**Ministry of Transportation**

April 25, 2019

As a follow up to the April 15, 2019 meeting with representatives from the Ministry of Transportation (MTO), Town of Hawkesbury, Township of Champlain and United Counties of Prescott and Russell (UCPR) in attendance, the MTO was requested to explain the rationale behind eliminating the Westbound on-ramp (N/S-W ramp) alternatives that were presented to staff on November 30, 2017 during the second Municipal Technical Advisory Committee (MTAC) meeting and to revisit these ramp options with the agreement that the posted speed limit would be reduced to 70km/h in the vicinity of the bridges. The posted speed limit changes that were presented and agreed to at the April 15, 2019 meeting are shown in Figure 1.

Figure 4: Channelized Right Turn with Sub-Standard Acceleration Lane and Merge Signs

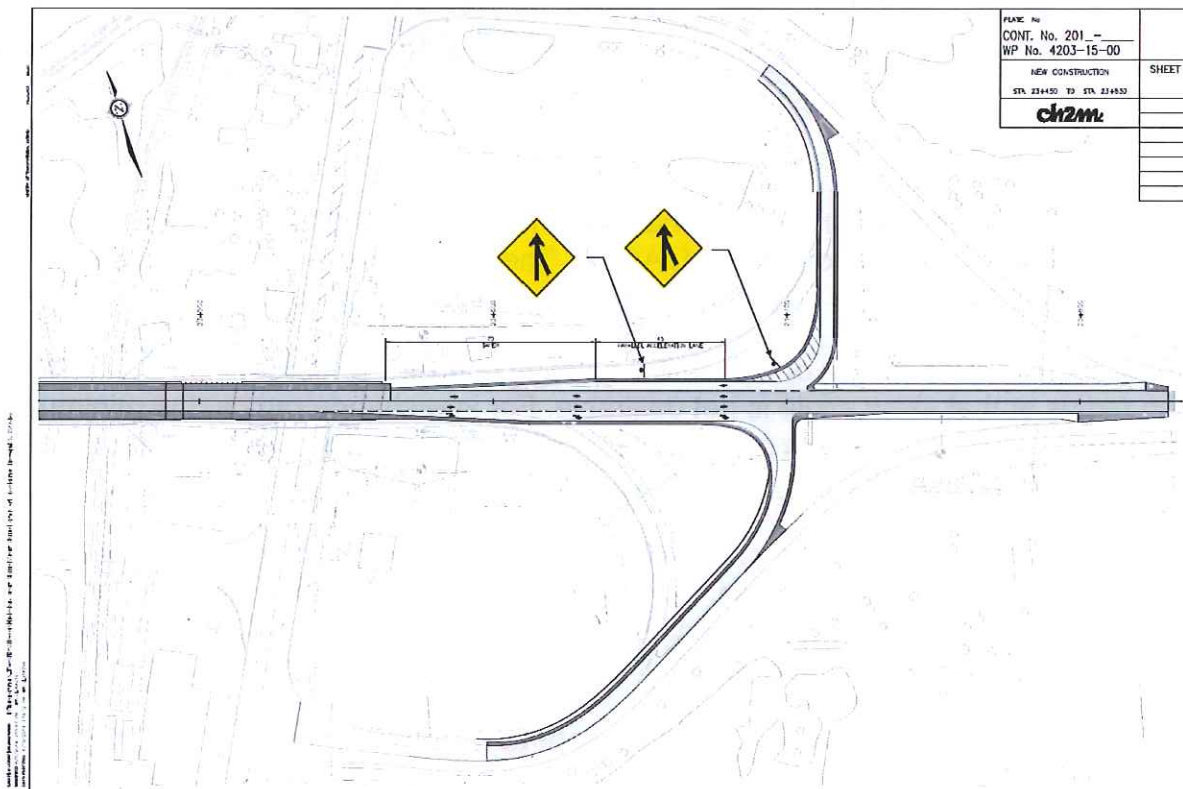
Jacobs looked at another version of a channelized right turn and an acceleration lane after the April 15, 2019 meeting. This option does not meet the minimum required acceleration lane length for free flow conditions (per GDSOH Section E.8.4) without widening the bridge. However, *sub-standard* acceleration lane lengths may be permitted, so long as they are controlled by signage (merge signs or yield signs per Ontario Traffic Manual (OTM) Book 5 and 6). This is shown in Figure 4 below. This is a feasible option, however, due to the sub-standard acceleration lane, vehicles and trucks will not have adequate space to get up to speed prior to the merge. Please note that Figure 4 will be the channelized right turn version that will be presented to the public, not Option A.
